# R2002 2L Fullset 5M12B

FDD\_LTE : B1/2/3/4/5/7/17/20

# Change notice

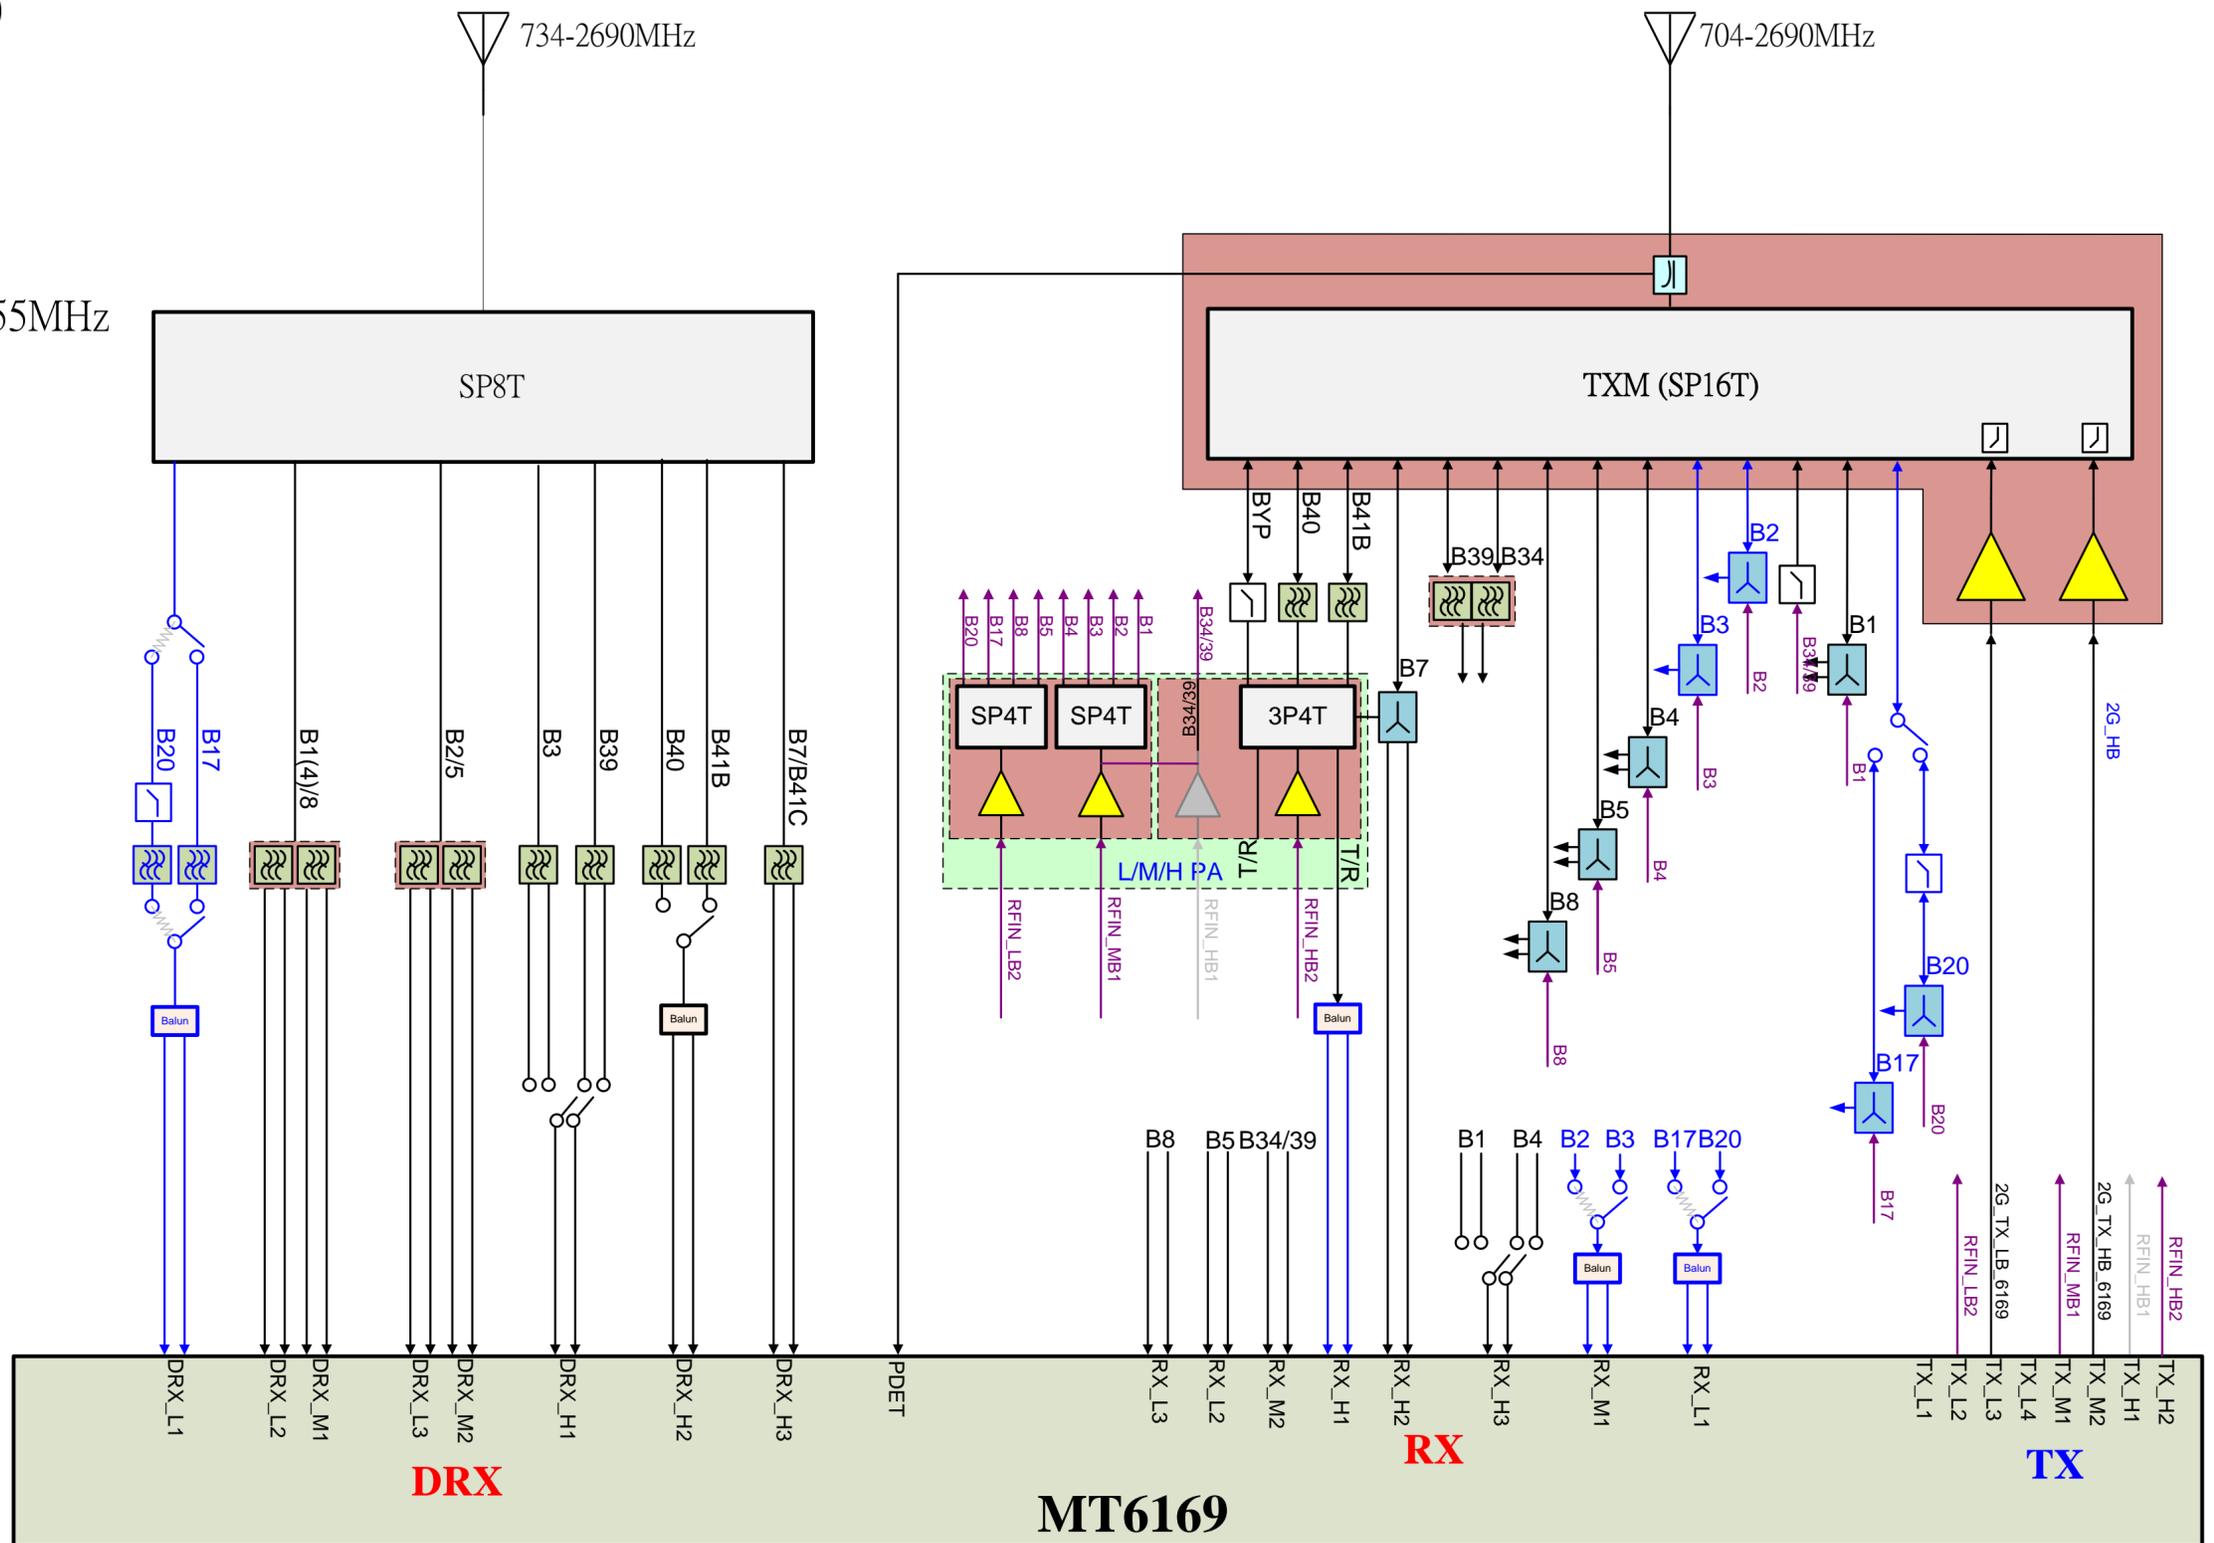
- 12/19 Remove B41A DRx SAW
- 12/19 Remove B3/B39 DRX single-end switch
- 12/19 Add description of B41M support frequency range
